Access Compliance Report

Public Rights-of-Way

Intersection ID: 25370	Main Street: PEVERELL_LN	Cross Street: PROVIDENCE_PLANTATION_LN	Location: E
ADA ID: 50D2ADD05176	Ramp Type: Perp	Initial Pass/Fail: Fail	Overall Compliance: No
		Severity Score: 35

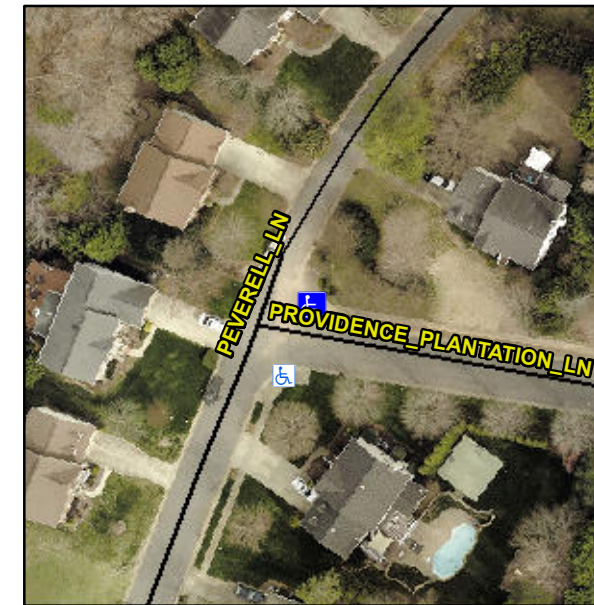
Not Found, R304.5.1

Compliance	Description	Data	Compliance	Description	Data
N/A	Ramp Length (in)	96.0	Yes	Ramp Slope (%)	5.1
No	Ramp Width (in)	29.0	Yes	Ramp XSlope (%)	0.8
N/A	Flare Type LT	N/A	N/A	Flare Type RT	N/A
N/A	Flare Slope LT (%)	N/A	N/A	Flare Slope RT (%)	N/A
N/A	Flare Traversable LT?	N/A	N/A	Flare Traversable RT?	N/A
N/A	Landing Length (in)	N/A	N/A	DWS Provided?	N/A
N/A	Landing Width (in)	N/A	N/A	DWS Contrast?	N/A
N/A	Landing Slope (%)	N/A	N/A	DWS Length (in)	N/A
N/A	Landing X Slope (%)	N/A	N/A	DWS Full Width?	N/A
N/A	Landing Curb? (Y/N)	N/A	N/A	DWS Offset (in)	N/A
N/A	Shared Landing?	N/A			
N/A	Gutter Ponding?	N/A	N/A	Gutter Slope (%)	N/A
N/A	Gutter Lip Ht (in)	N/A	N/A	Gutter X Slope (%)	N/A
N/A	Painted X Walk1?	No	N/A	Painted X Walk2?	N/A
	X Walk 1 Direction	To SW		X Walk 2 Direction	N/A
N/A	X Walk 1 Width (in)	N/A	N/A	X Walk 2 Width (in)	N/A
	X Walk 1 Slope (%)	1.8		X Walk 2 Slope (%)	N/A
	X Walk 1 X Slope (%)	1.9		X Walk 2 X Slope (%)	N/A

Remove & Replace Entire Ramp.
